**RESPONSE TO AN BORD
PLEANALA OPINION
STRATEGIC HOUSING DEVELOPMENT-
1-4 EAST ROAD, DUBLIN 3**

CLIENT
Glenveagh Living

DATE
26th April 2019

Response to ABP Opinion

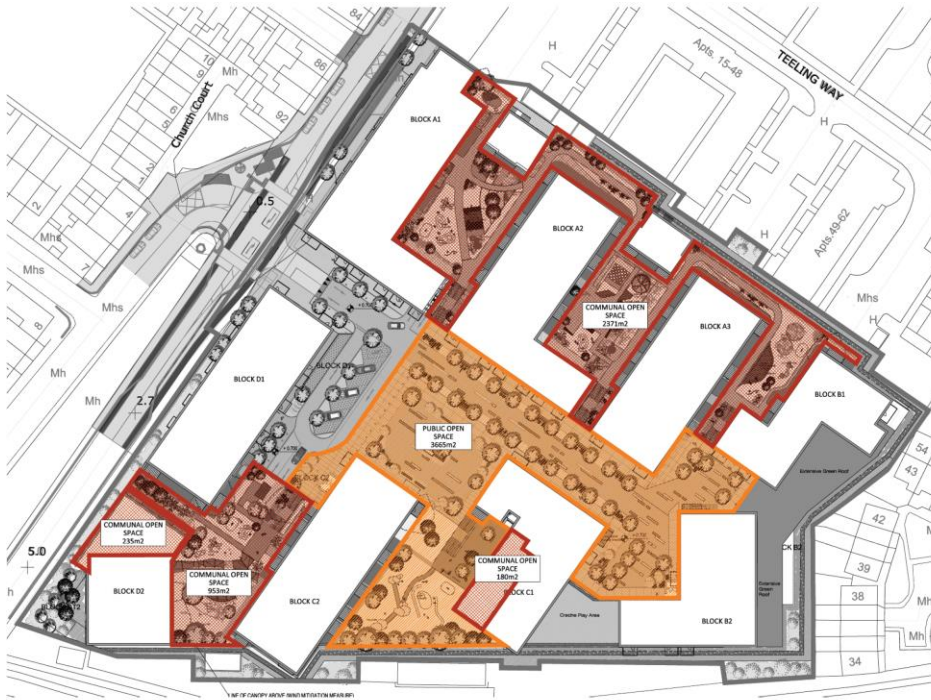
Item 6 of the ABP Opinion states:

A detailed landscaping plan for the site which clearly sets out proposals for hard and soft landscaping including street furniture where proposed and indicates which areas are to be accessible to the public.

The application is accompanied by both detailed landscape drawings and supporting Landscape Design Rationale Report which clearly outlines the proposals for hard and soft landscaping.

As is clarified in the Report and replicated in the image below, the plaza and public realm, in addition to podium courtyard 5 (which includes the crèche entrance) are fully accessible to the public. This area represents 17% of the site area (significantly in excess of the required 10% public open space).

The remainder of the courtyards, and roof terraces, are accessible only by the residents of the scheme.
